February 24, 1975

Serial: NG-75-212

H. B. ROBINSON UNIT NO. 2
LICENSE DPR-23
CORRECTION OF SUBMITTED DATA IN
SECOND REFUELING OUTAGE SUMMARY REPORT

Figure 1

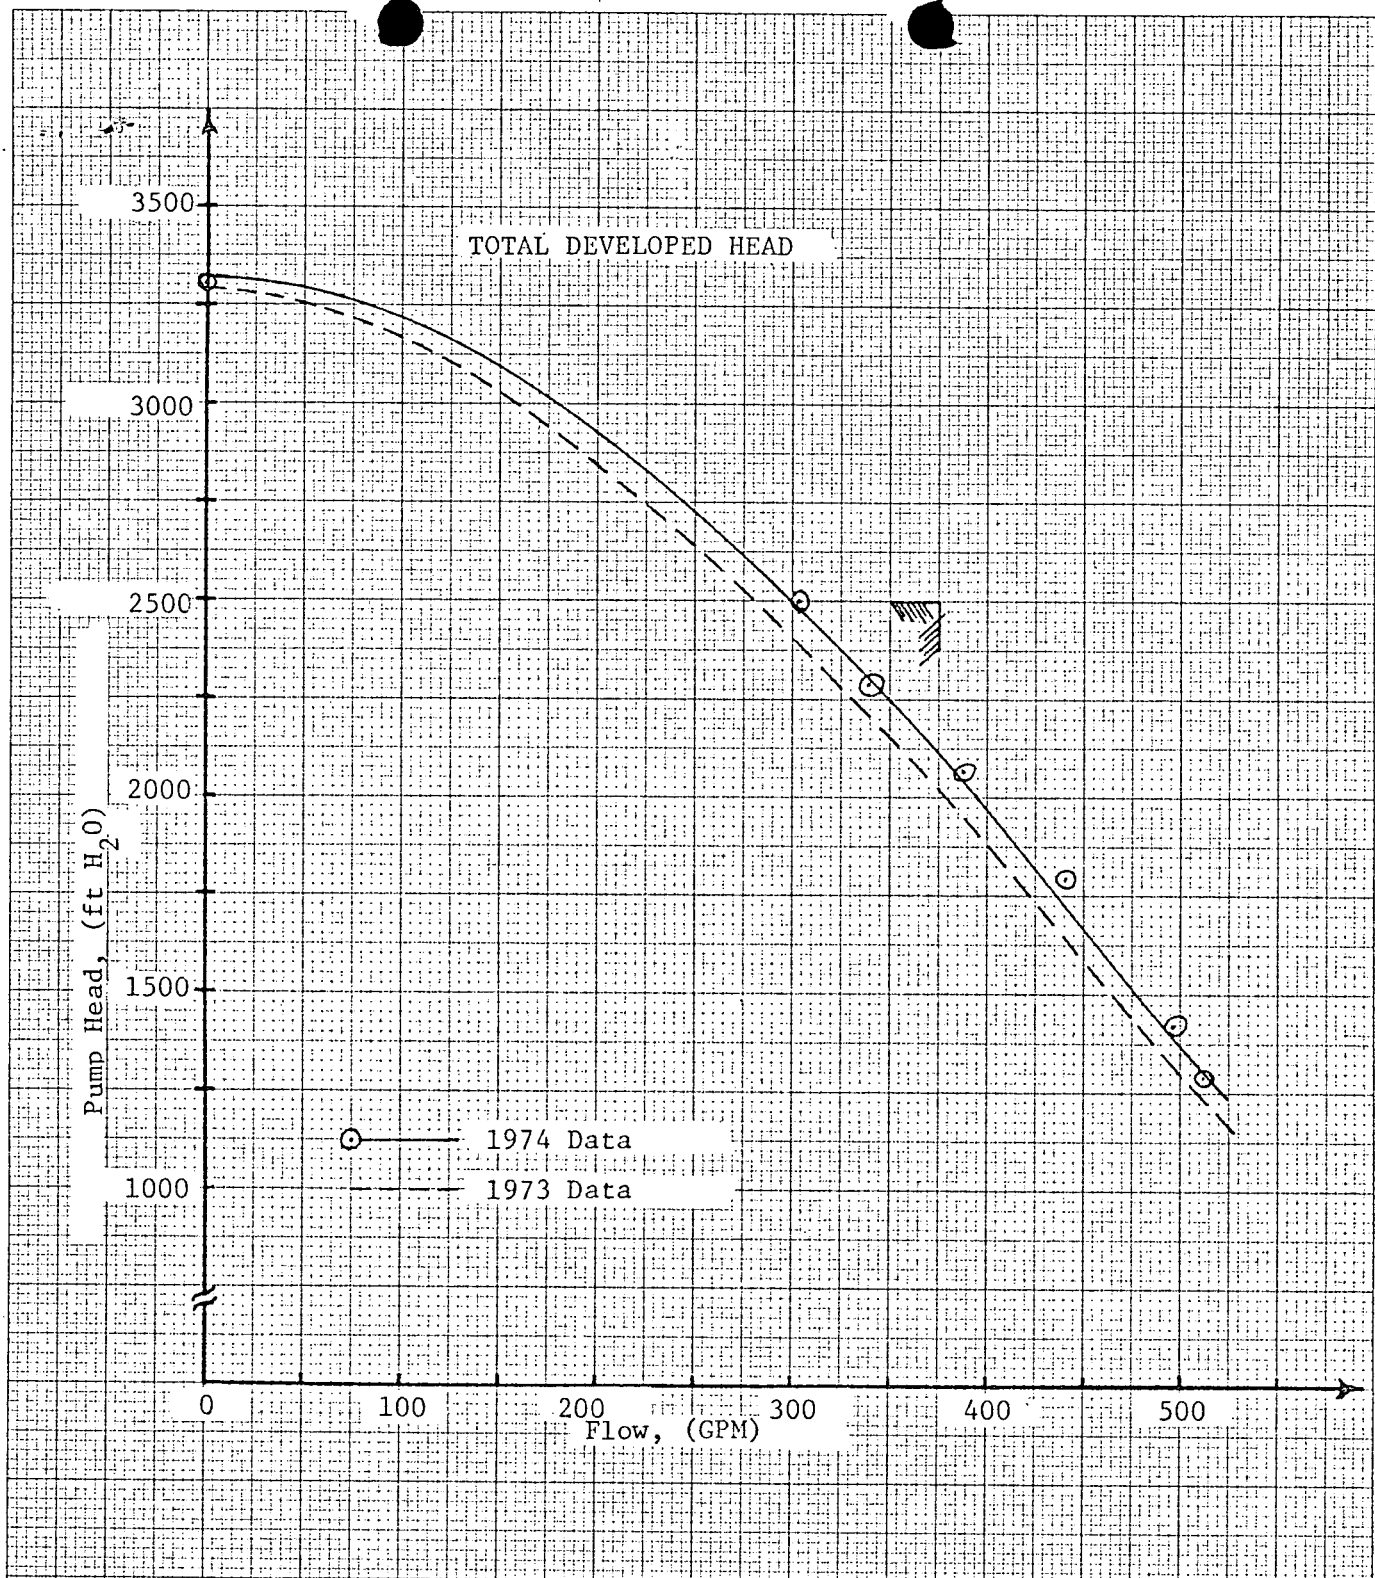
On October 7, 1974, Carolina Power & Light Company submitted a report entitled "H. B. Robinson Unit No. 2 - Second Refueling Outage - Summary of Events of Interest," which was provided at the request of the Directorate of Regulatory Operations. During subsequent inspection of figures included in the report, it was discovered that several graphs pertaining to safety injection system performance were deficient in that values of the ordinates and abscissas were missing or erroneously labeled. To correct this deficiency, we hereby submit revised Figures 1 through 4 of the subject report with the proper information.

Figure 4
INJECTION TO
REACTOR COOLANT SYSTEM

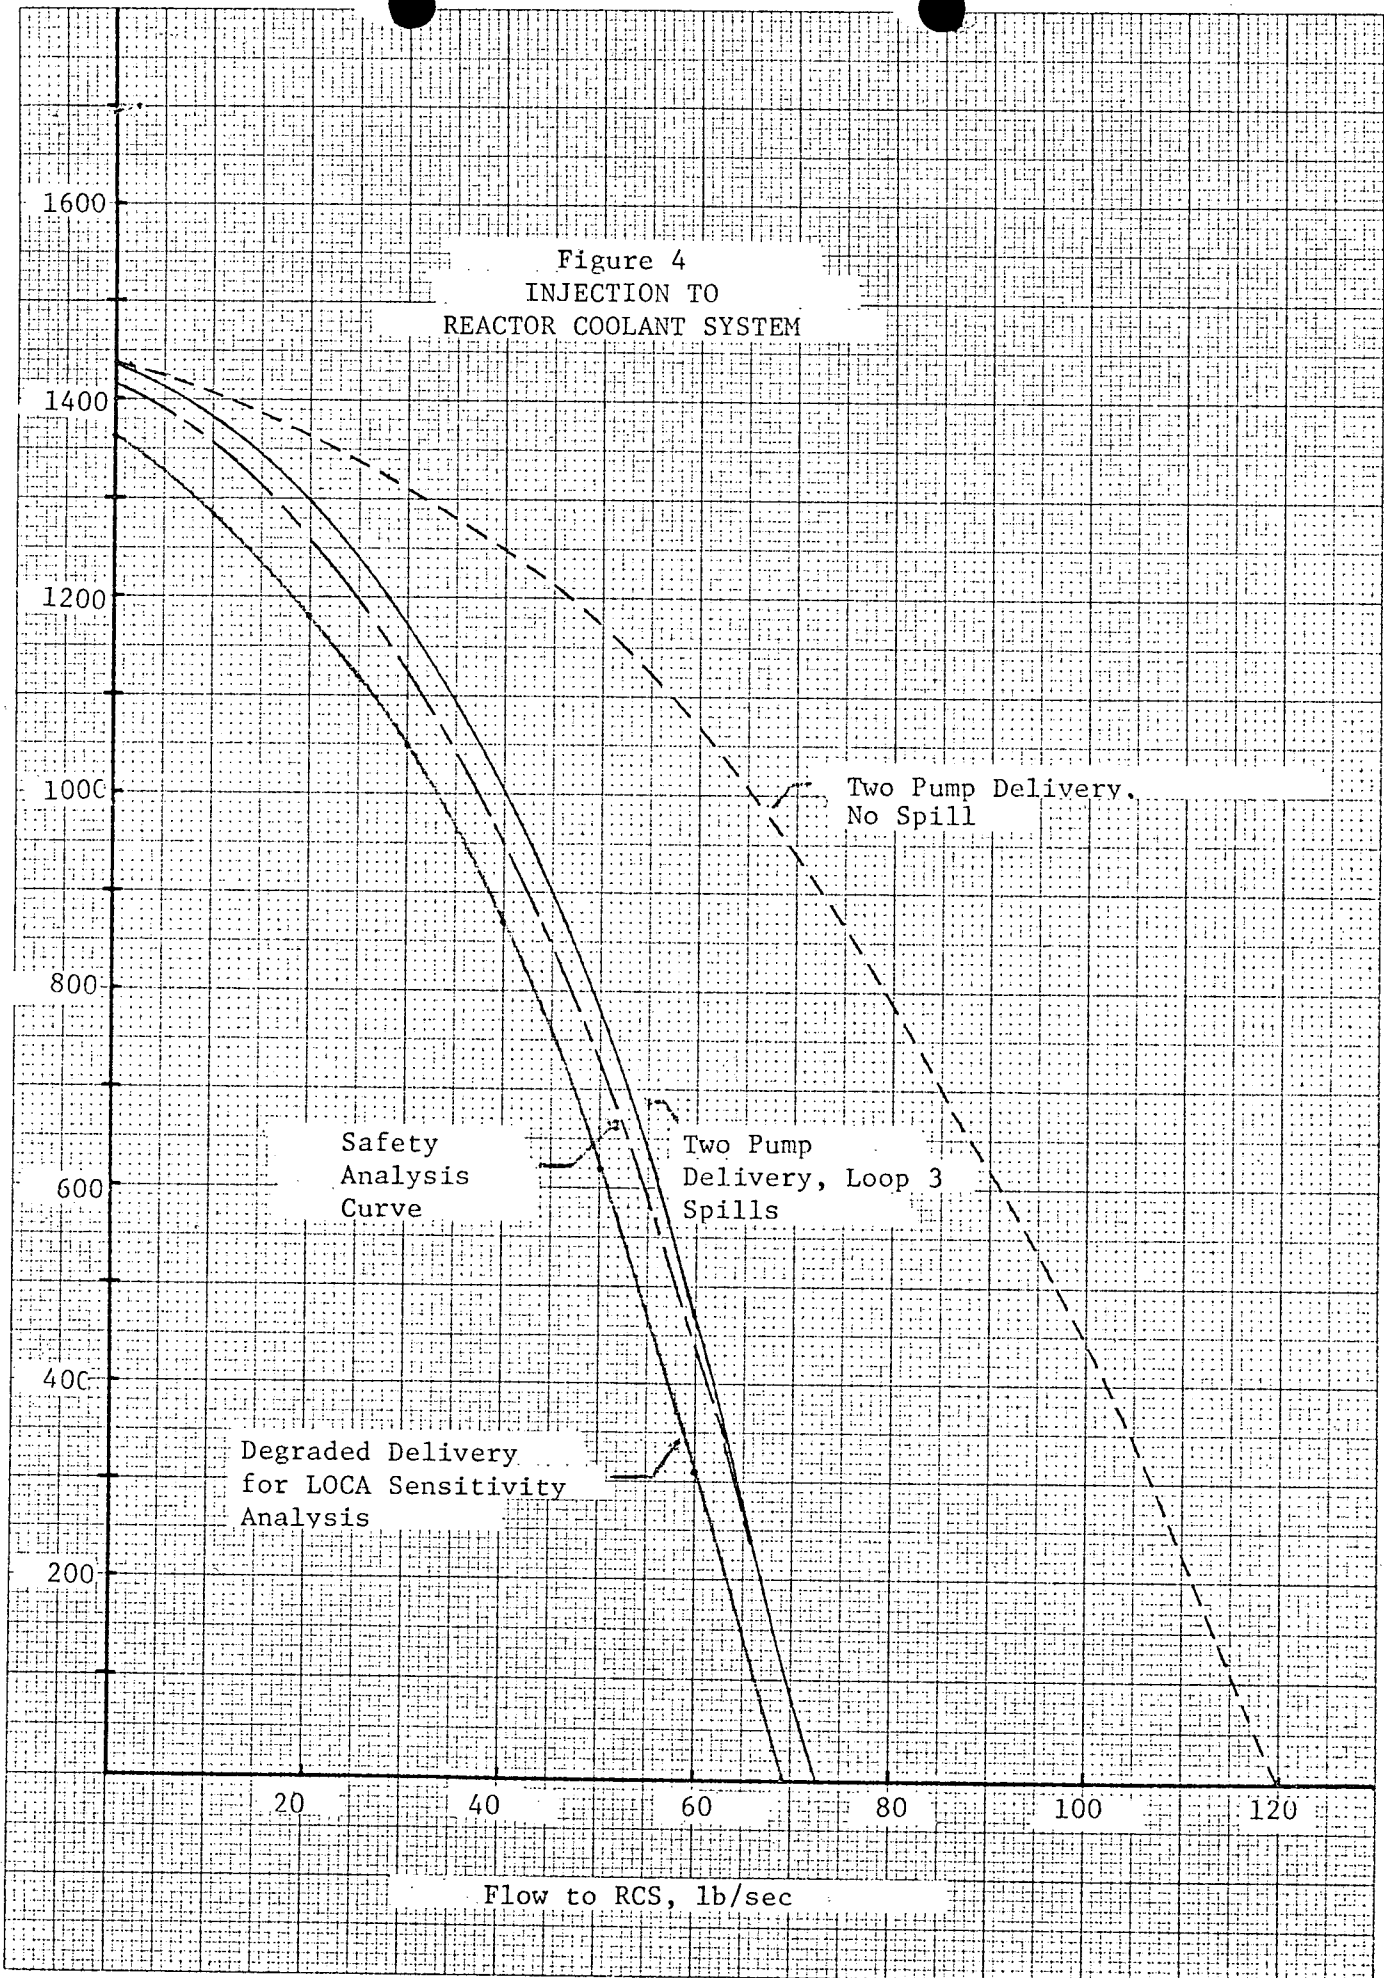
In addition, we have added an additional system delivery curve to Figure 4, Injection to Reactor Coolant System, to show the degraded delivery for the LOCA sensitivity analysis presented in our submittals of September 7, 1973 and January 4, 1974. You should replace the original figures in your copies of the October 7, 1974 report with the figures in this submittal.
